HISTORIC AND DESIGN REVIEW COMMISSION

June 07, 2023

HDRC CASE NO: 2023-187
ADDRESS: 141 ZERM RD
LEGAL DESCRIPTION: NCB 7675 BLK LOT S 74.75 FT OF 4
ZONING: R-6, H, MPOD-2
CITY COUNCIL DIST.: 3
DISTRICT: Mission Historic District
APPLICANT: Jenny Hernandez
OWNER: Robert Howard/HOWARD ROBERT D
TYPE OF WORK: Construction of a 1-story, single-family residential structure
APPLICATION RECEIVED: May 11, 2023
60-DAY REVIEW: July 10, 2023
CASE MANAGER: Edward Hall

The applicant is requesting a Certificate of Appropriateness for approval to construct a 1-story, single-family residential structure on the vacant lot at 141 Zerm Road, located within the Mission Historic District.

PLOT PLAN

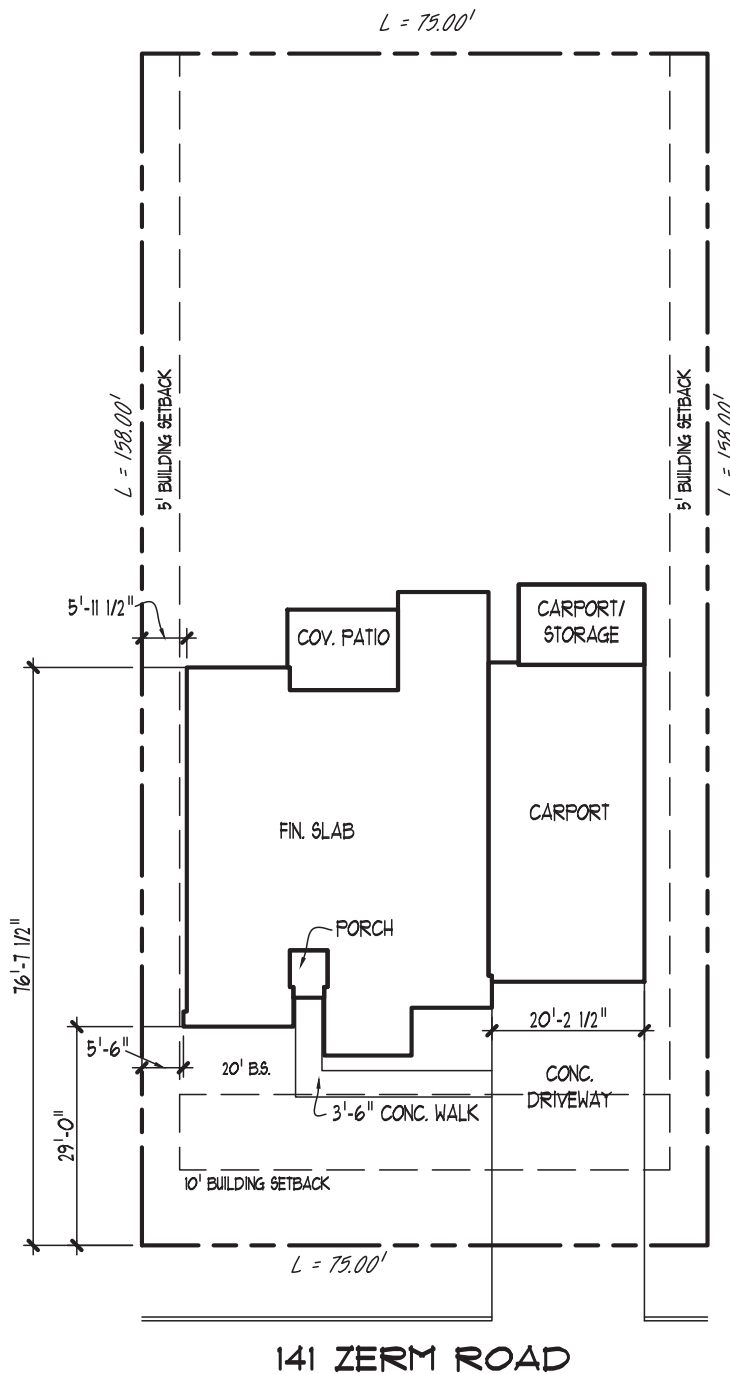
- d. **SETBACKS & ORIENTATION** – According to the Guidelines for New Construction, the front facades of new buildings are to align with front facades of adjacent buildings where a consistent setback has been established along the street frontage. Additionally, the orientation of new construction should be consistent with the historic examples found on the block. The applicant has not noted the proposed setback in relationship to the existing structure on the block. Staff finds that a setback diagram should be provided to OHP staff for review and approval. The proposed setback should be consistent with the Guidelines.

- r. DRIVEWAY – The applicant has noted a driveway width of twenty (20) feet. The Guidelines for Site Elements notes that driveways within historic districts should be limited to ten (10) feet in width. Staff finds that the proposed driveway should be limited to no more than ten (10) feet in width.

- i. That a setback diagram be provided to OHP staff for review and approval. The proposed setback should be consistent with the Guidelines, as noted in finding d.

- viii. That the proposed driveway be limited to no more than ten (10) feet in width, as noted in finding r.
- ix. That a detailed landscaping plan be submitted for review and approval as noted in finding q.
